## **PEER REVIEW PANEL REPORT**

Of the Southwest Florida Water Management District's document  
**A Reevaluation of Minimum Flows  
for the Upper Peace River  
from Bartow to Zolfo Springs, Florida**

Prepared for: Southwest Florida Water Management District  
Peer Review Panel: Harry Downing, John Loper, Adam Munson

Date:  
2/16/2026

## 2 Justification for the Assumption of Linearity in Streamflow Response to Groundwater Pumping

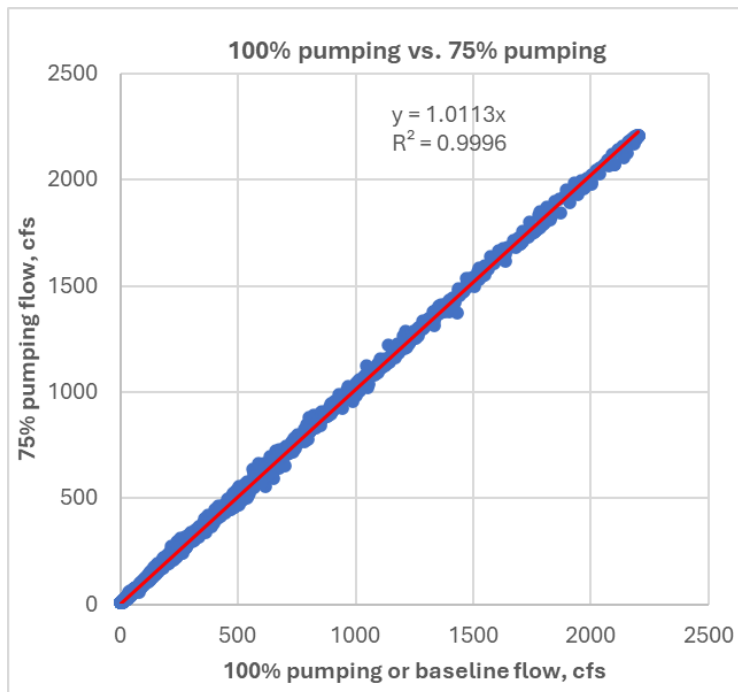
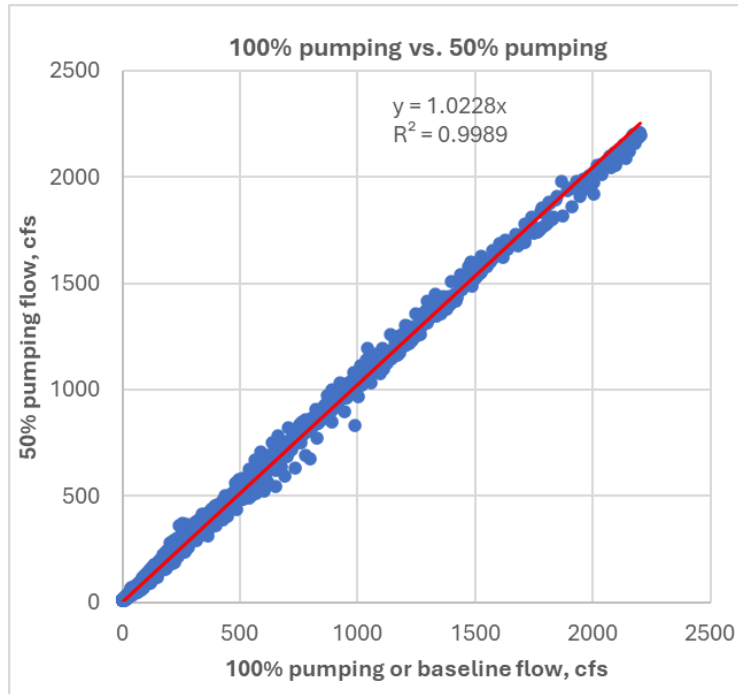
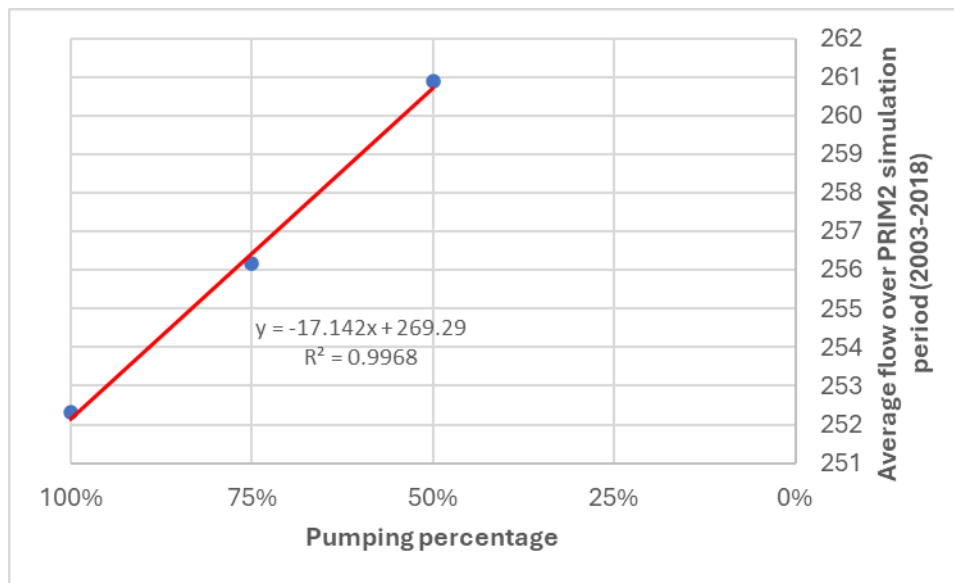
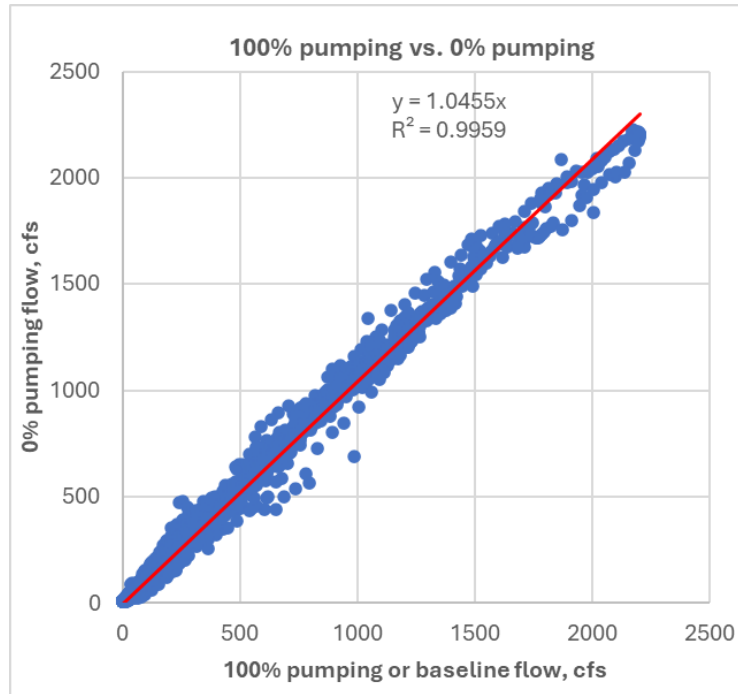
10	AM	P 178-180 and Appendix C	Perhaps	<p>Assuming an approximately linear response of streamflow to pumping reduction across a <i>very large</i> change (from 50% to 0%), nonlinearity could appear if groundwater levels rise enough to change exchange dynamics (e.g., crossing the riverbed elevation, activating different leakage pathways, etc.)</p> <p>PRIM2 is still the best information available. Models by their nature are imperfect representations of reality and the model the district has created is impressive. Still the report treats this extrapolation as routine with little justification. However, the importance of the baseline flow justifies greater discussion of this extrapolation.</p>	The report would benefit from greater justification for the extrapolation. I believe the best form this could take would be additional runs supporting the response linearity, preferable beyond 50%. In the absence of that it appears a 75% reduction run has been completed and could be included to bolster confidence in the linearity of the relationship

In addition, the 16-year (2003-2018) average daily flow values also exhibit a strong linear relationship, as shown in Figure 3. Based on these results, the relationship illustrated in Figure 3 supports extrapolating the baseline streamflow at the Fort Meade gage for no withdrawal (0% pumping) scenario by doubling the difference between 100% pumping and 50% pumping simulations. The comparison between the 100% pumping scenario and the extrapolated 0% pumping is presented in Figure 4, which likewise shows a linear relationship.

These same observations apply to the Bartow and Zolfo Springs gages.
